2177 OF 1926
4/3/1926

With reference to ^{his}~~their~~ application dated 8.2.26 with aplan for the proposal ^{Building}~~additional~~ on plot No. 104 Survey Sheet No. E-7.

— PLAN SHOWING ADDITIONS & ALTERATIONS IN BUILDING ON —
— PLOT N^o 104 SHEET E-7 —

— RANCHORE Q^o —

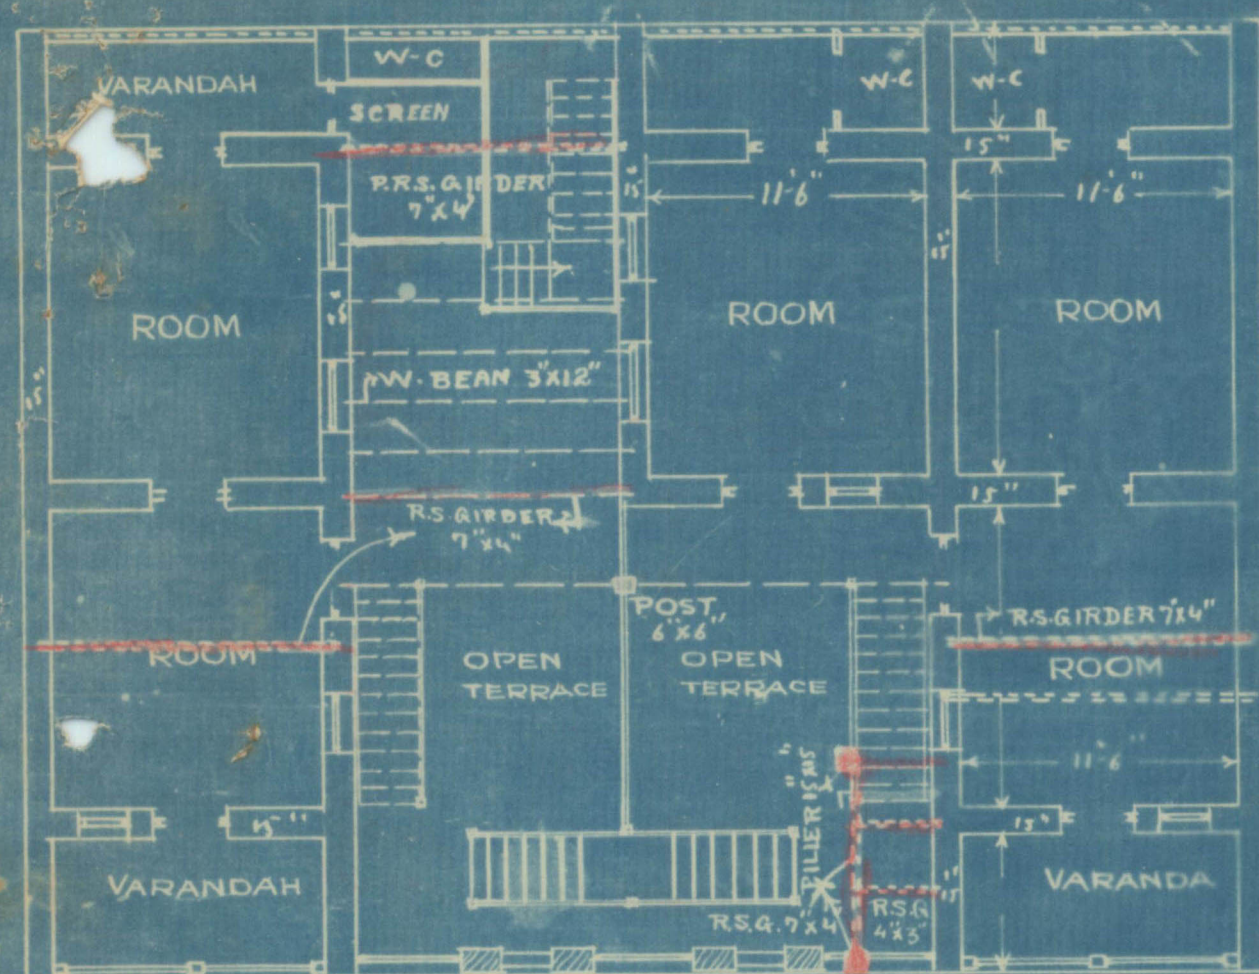
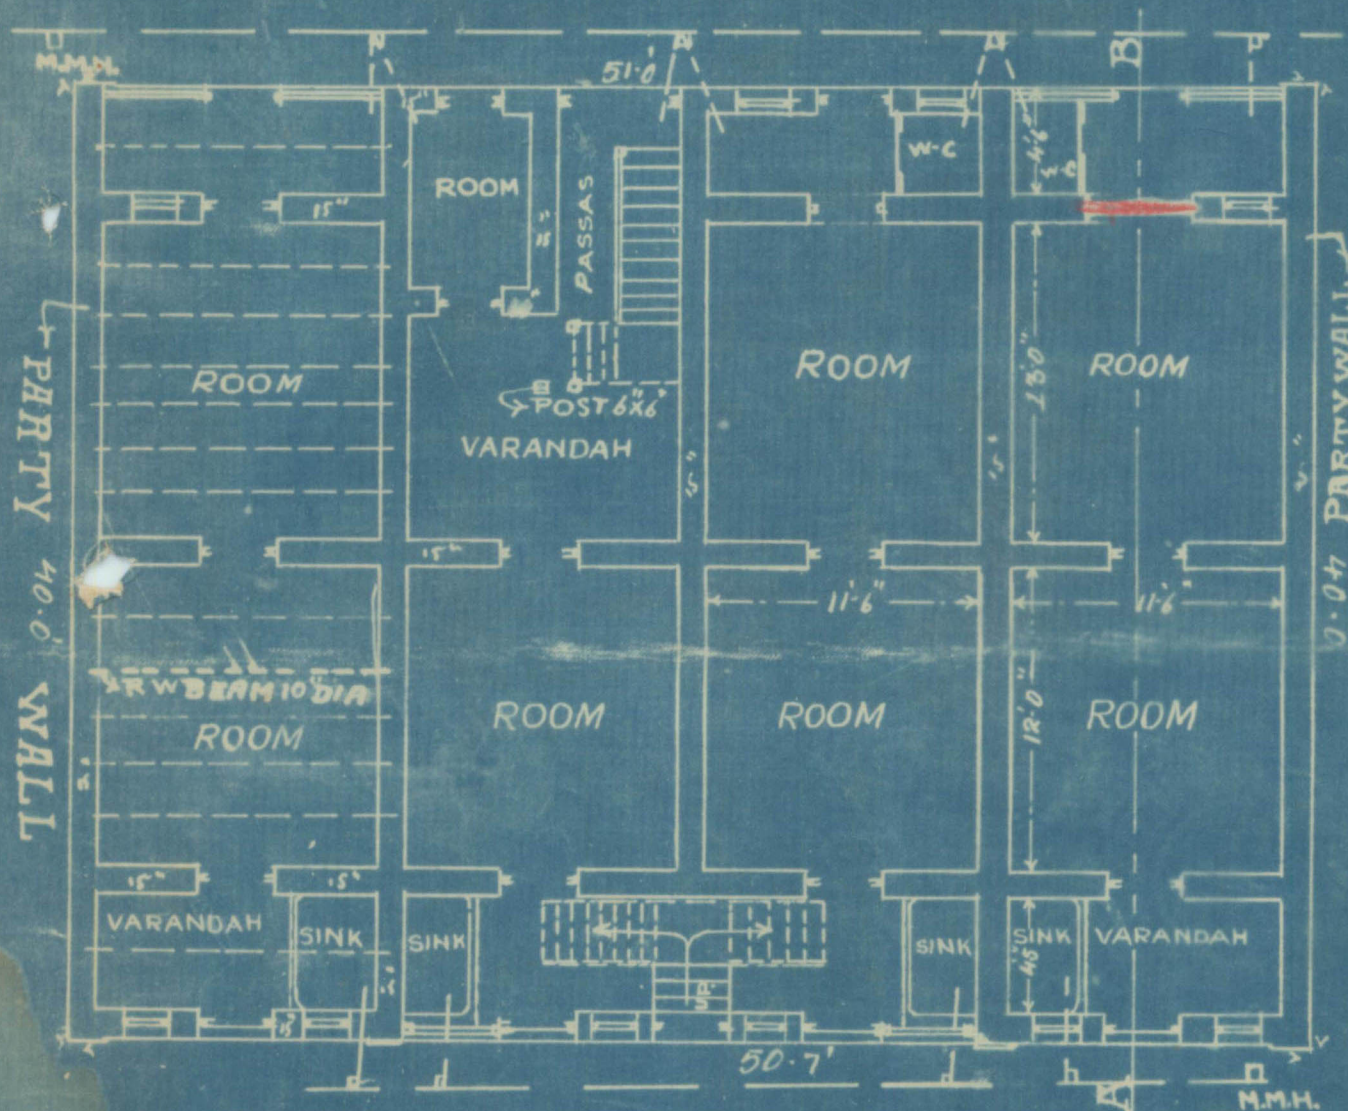
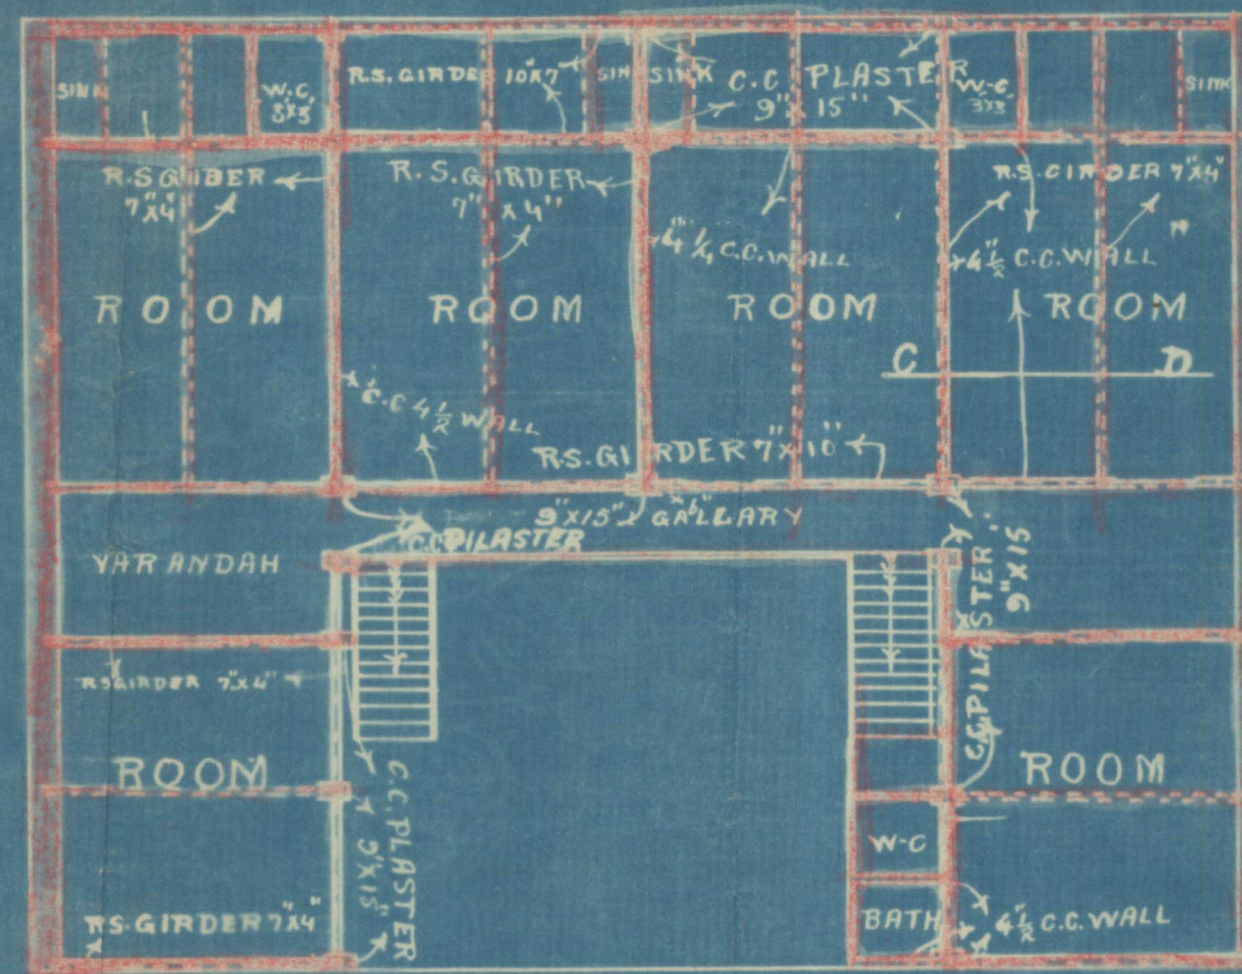
- (1) Existing building is unfit for human habitation.
- (2) Back to back rooms let to different tenants are objectionable.
- (3) Existing building must be improved & sanitary conveniences must be provided.
- (4) Thickness of walls are insufficient.
- (5) Foundation must be opened out.
- (6) Dimensions for rooms on new floor must be given. W.C. & bath over staircase cannot be allowed & their dimensions at all places must be put on plan.
- (7) The existing Calm on 3rd floor must be shown on plan.
- (8) Title deed must be produced.
- (9) The walls for ground & 2 upper must be 18" at bottom & 15" for ground & 1st floors.

Building Surveyor's Report Thickness of walls are insufficient.
Foundation must be opened out. Sizes Dimensions for
rooms on new floor must be given. W.C & bath over
Staircase cannot be allowed and their dimensions at
all places must be put on plan. There is a cabin
on 3rd floor existing on the north side, Is and from
enquiry on site the owner does not want to remove it.
Architect has seems to have forgotten about it. It
must be shown on plan. Title deed must be produced.

Super as per H.O. & B's sketch
the walls for gr + 2 up to must be
18" at bottom + 15" for gr + 1 at top
